NEW YORK STATE DEPARTMENT OF ENVIRONMENTAL CONSERVATION DIVISION OF ENVIRONMENTAL REMEDIATION PRAP/ROD ROUTING SLIP

PROPOSED REMEDIAL ACTION PLAN Youngstown Cold Storage Site

Environmental Restoration Project Village of Youngstown, Niagara County, New York Site No. E932122

Village of Youngstown, Niagara County, New York Site No. E932122 August 2006

FIGURE NO. 3

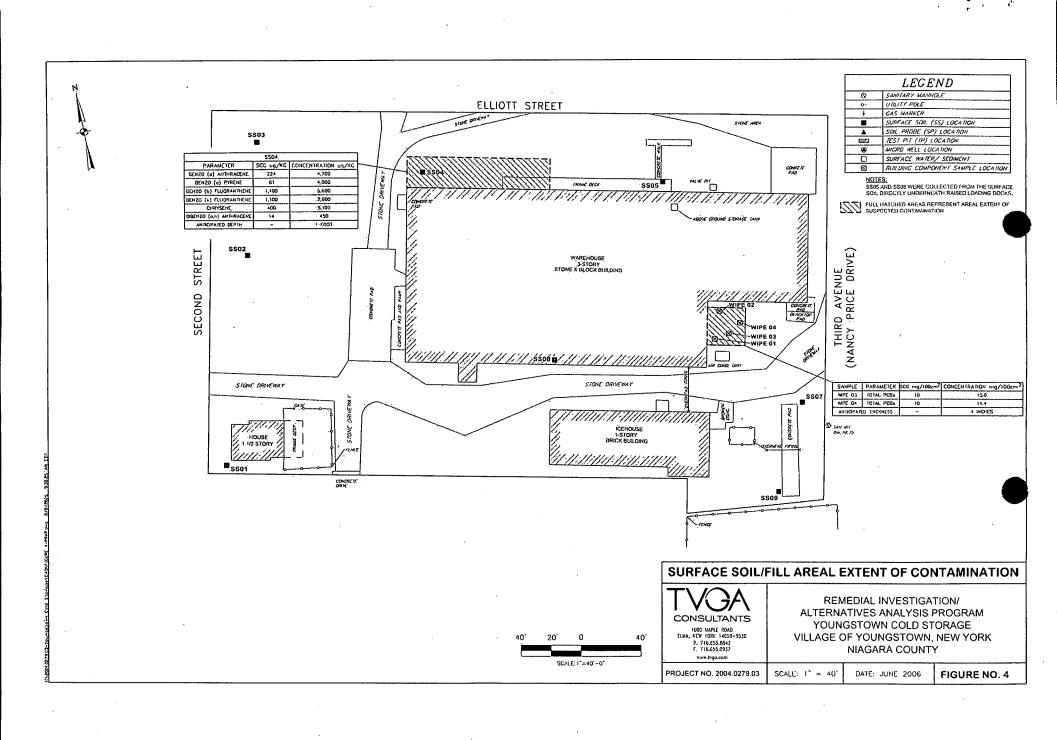
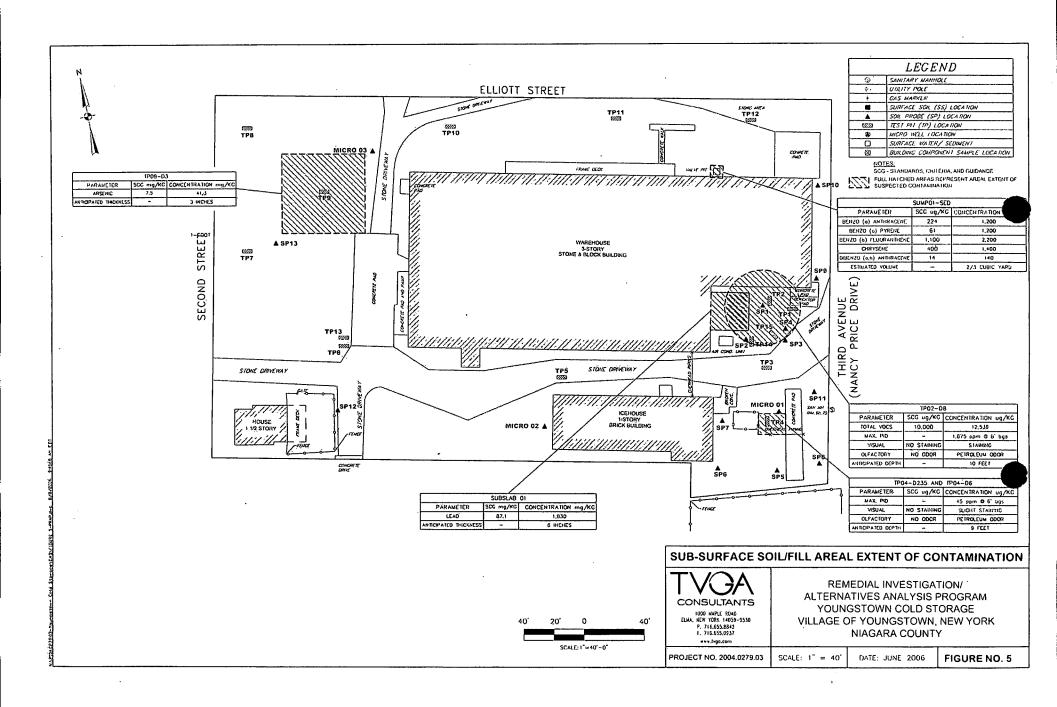
Figure stays 2 stary text on page 3 says 3 star page 16
